**INSPECTION OF HABIB RAHMAN SECONDARY SCHOOL
CONSTRUCTION PROJECT IN KAPISA PROVINCE:
DESIGN AND SAFETY ISSUES REQUIRE ATTENTION**

October 26, 2009

SUBJECT: SIGAR Inspection Report 10-3: Inspection of Habib Rahman Secondary School
Construction Project in Kapisa Province: Design and Safety Issues Require Attention

Figure 2: Design Plan for the Habib Rahman Secondary School which builds around a previously built, unfinished structure (shaded in yellow) rather than demolishing it. (Illustration provided by Kapisa PRT)

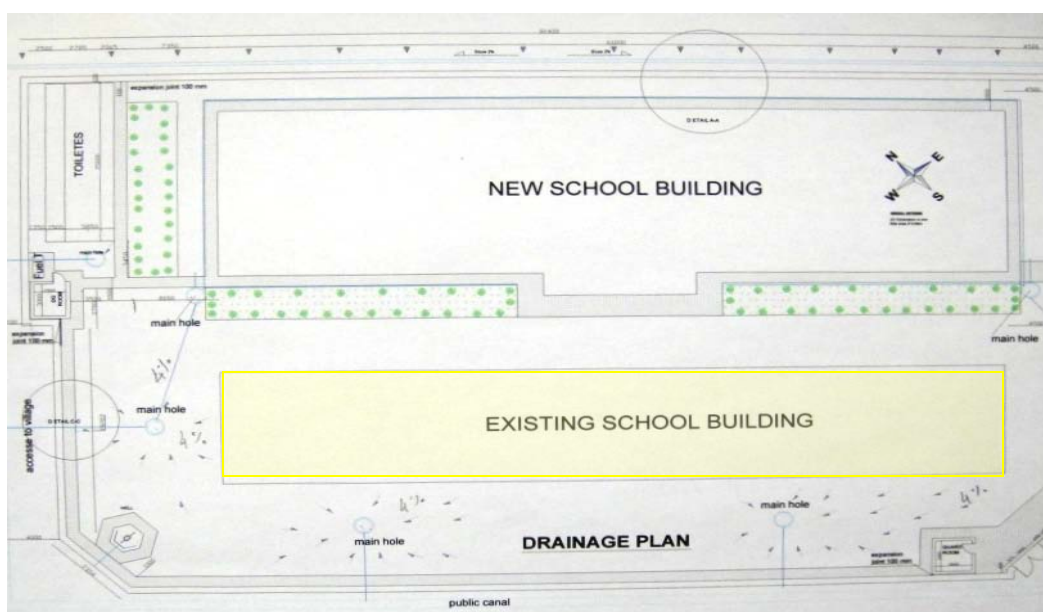
The first design flaw in the project noted by SIGAR focuses on the existence of a previously constructed but unfinished and unsafe structure (see Site Photo 2 and Figure 2) which occupies valuable land that could be used for a number of other purposes.³ When the Kapisa PRT became involved in the school project in the summer of 2008 following discussions with the Provincial Director of Education, it was decided that the existing structure should not be used because of concerns regarding its structural soundness. The current contract did not require the removal of this prior construction and PRT officials noted that they do not have plans to remedy this problem. SIGAR could not determine why this unfinished and unsafe structure was not demolished as part of the initial project proposal except for statements from the current PRT staff which indicated that local authorities believed they could make use of the unfinished structure. Despite attempts to

RECOMMENDATION 1: SIGAR recommends that the Commander, U.S. Forces-Afghanistan and Commander, Kapisa PRT initiate a follow-on CERP project to correct the design deficiencies noted in this report to include demolishing the previously built but unusable structure on the school compound, and constructing a protective retaining wall at the rear of the new school in place of the perimeter wall. (page 6 of SIGAR report)

KP PRT RESPONSE: Kapisa PRT partially concurs with information provided in this SIGAR Report. A follow-on project should be implemented for correcting the rear security wall and potentially adding a retaining wall and proper drainage. The reinforced concrete frame of the previously built school was left on site at the request of Nijrab government officials and local shura leaders. The engineers of the area are working to get funding to build a small community center and/or library on the site that may use some of the existing structure.
